### **DRAWING AMENDMENTS**

PATENT APPLICATION  
10/696,705

**Circuit Arrangement and Method for  
Sequential Classification of a Plurality of  
Controllable Components**

FIG 3 Prior Art

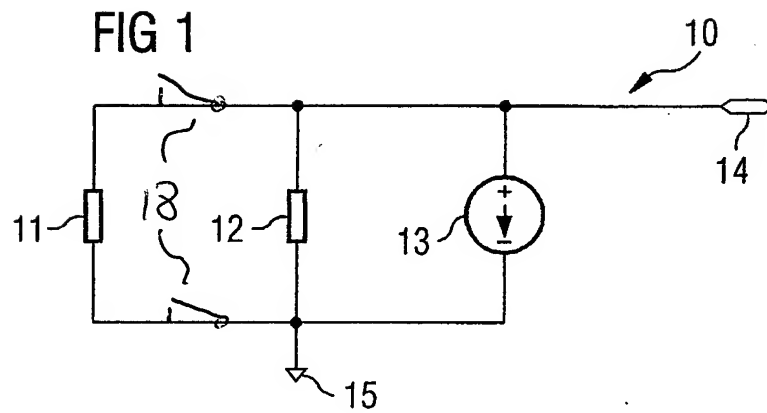
To this end, Fig. 3 showing the prior art now includes a first and second switch as switching means 18. The original specification states that switches are provided to couple the resistor 11 with ground and with the resistor network 321, 322, 323. The specification particularly states that the resistor 11 is “... *connected on one side, by switching means not shown, to ground 15. On the other side it is connected to a series circuit of voltage divider resistors 321, 322 and 323...*” (emphasis added) See specification page 13, line 17-19. Thus, Fig. 3 now shows these switches. No new matter has been added. With respect to Fig. 1, the specification states: “*Instead of the voltage divider circuit according to the prior art, a single reference or measuring resistor 12 is connected here in parallel to the calibration resistor to be recorded in each case.*” See page 14, lines 24-26. Thus, the switching means would be applied in a similar way as shown in Fig. 3. The amendments to Fig. 1, therefore, now also show the switches 18. With respect to Figs. 5A and 5B, Applicant amended these drawings as described in the original specification. The specification states: “*As can be easily seen, the entire calibration network can be connected to the calibration resistor of interest in the most simple way with the switching resources not shown a...*” See page 17, lines 1-3. The simplest way to connect a resistor to a circuit is a simple switch as now shown. Thus, no new matter has been added. Applicant believes that all necessary elements are now shown in the drawings as original disclosed.

**FIG 5A**

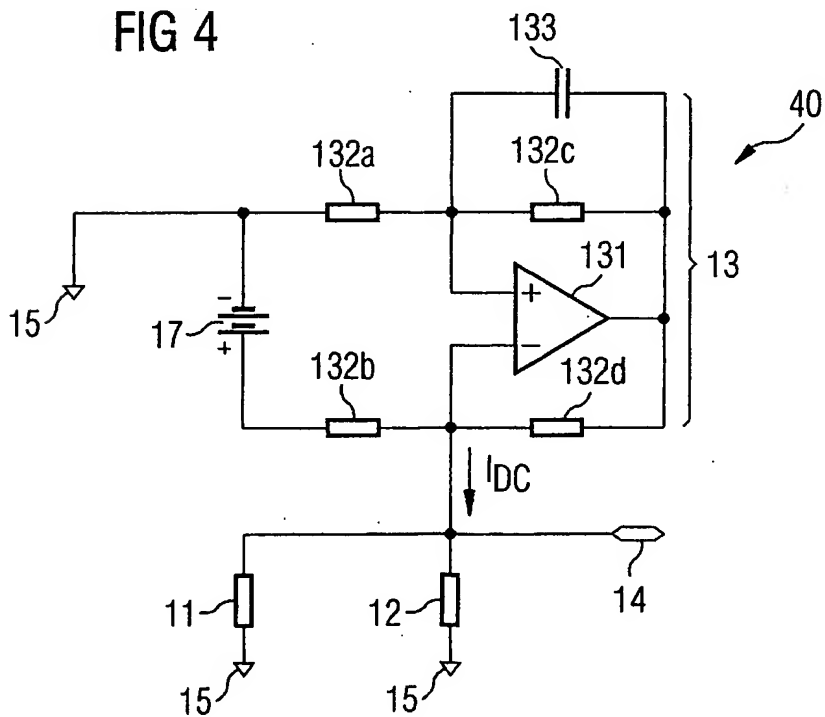
With respect to claim 4 the Examiner stated that the drawings fail to show the diodes. Applicant respectfully disagrees. Fig. 5A clearly shows diodes 163a...163h. For a better overview, Fig. 5A only shows a single resistor 11 coupled with diode 163a. Each other resistor is coupled with the remaining diodes 163b...163h in exactly the same way. Thus, there is no need to show these resistors and associated switches. The specification states: “*To improve clarity the calibration resistors to be connected to the decoupling diodes 163b-h are not shown in the diagram. The other components correspond to the relevant components with the same reference character in Figs. 1, 2 and 4.*” See page 17, lines 5-8. Applicant believes

by showing one resistor 11 coupled with the network, a person skilled in the art will not have any problems understanding how the remaining resistors have to be connected.
